APICAL INDUSTRIES, INC.
dba DART AEROSPACE

ENGINEERING CHANGE NOTICE NO.

DWG NO. 647.7700

DWG TITLE: STRUT ASSY

SHEET 2, ZONE D4 IS:

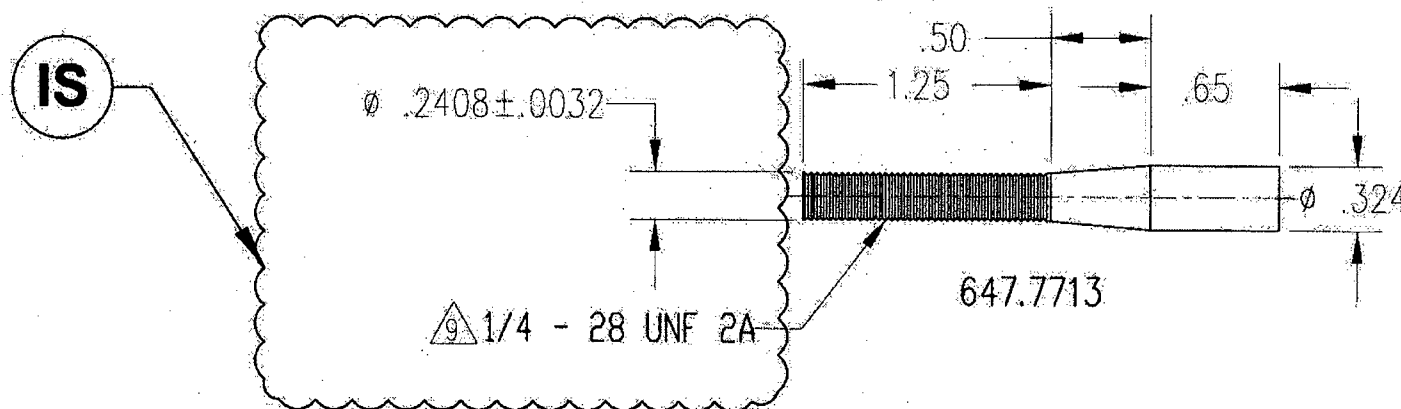
REASON: REVISED DIMENSION

UNINCORPORATED ECN(s)

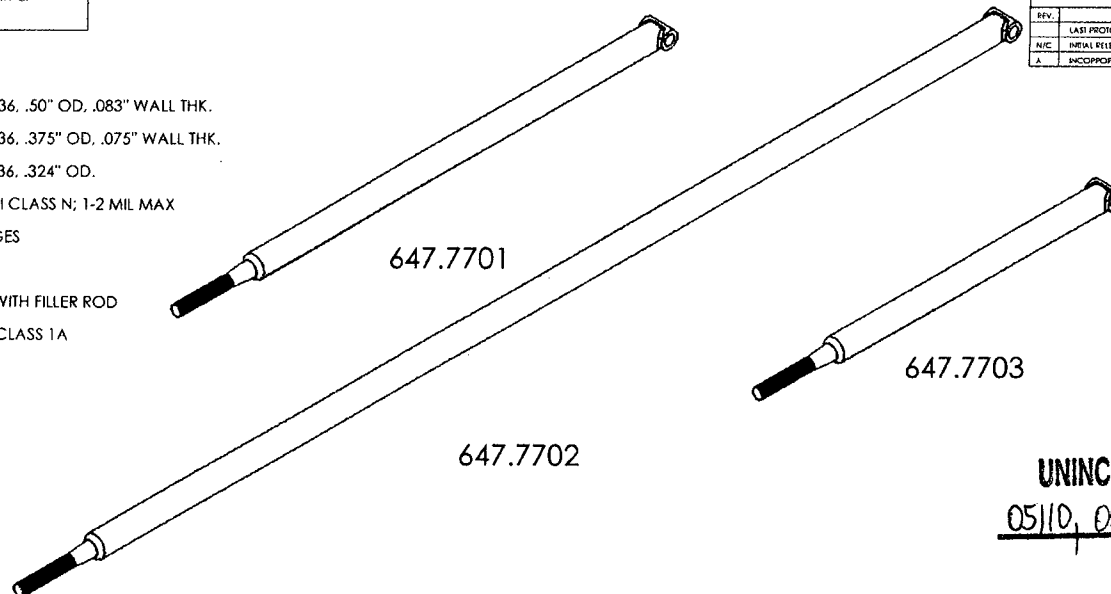
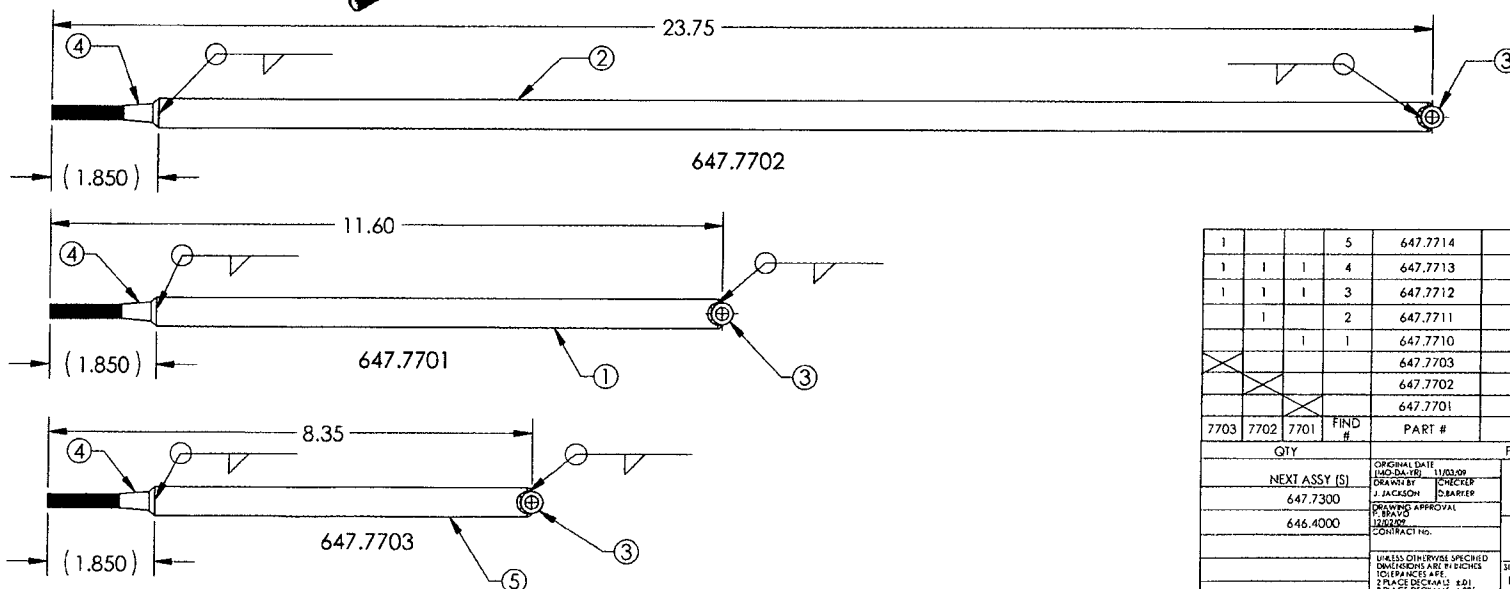
REASON: REVISED FINISH CALLOUT AS PER ECR 15-209

SHEET 1, NOTES IS:

- 1 MATERIAL: 4130 STEEL PER AMS-T-6736, .50" OD, .083" WALL THK.
- 2 MATERIAL: 4130 STEEL PER AMS-T-6736, .375" OD, .075" WALL THK.
- 3 MATERIAL: 4130 STEEL PER AMS-T-6736, .324" OD.
- 4 FINISH: PRIME IAW MIL-P-2337J TYPE I CLASS N; 1-2 MIL MAX
5. DEBURR AND BREAK ALL SHARP EDGES
6. IDENTIFY IAW MPP-120.
- 7 WELD IAW MIL-STD-2219, TIG WELD WITH FILLER ROD
- 8 FINISH: CAD PLATE IAW QQ-P-416F CLASS I TYPE II
- 9 MASK THREAD PRIOR TO FINISH

1. MATERIAL: 4130 STEEL PER AMS-T-6736 .50" OD, .083" WALL THK.
2. MATERIAL: 4130 STEEL PER AMS-T-6736 .375" OD, .075" WALL THK.
3. MATERIAL: 4130 STEEL PER AMS-T-6736 .324" OD.
4. FINISH: PRIME IAW MIL-P-2337J TYPE I CLASS N; 1-2 MIL MAX
5. DEBURR AND BREAK ALL SHARP EDGES
6. IDENTIFY IAW MPP-120.
7. WELD IAW MIL-STD-2219. TIG WELD WITH FILLER ROD
8. FINISH: CAD PLATE IAW MIL-C-5541 CLASS 1A
9. MASK THREAD PRIOR TO FINISH
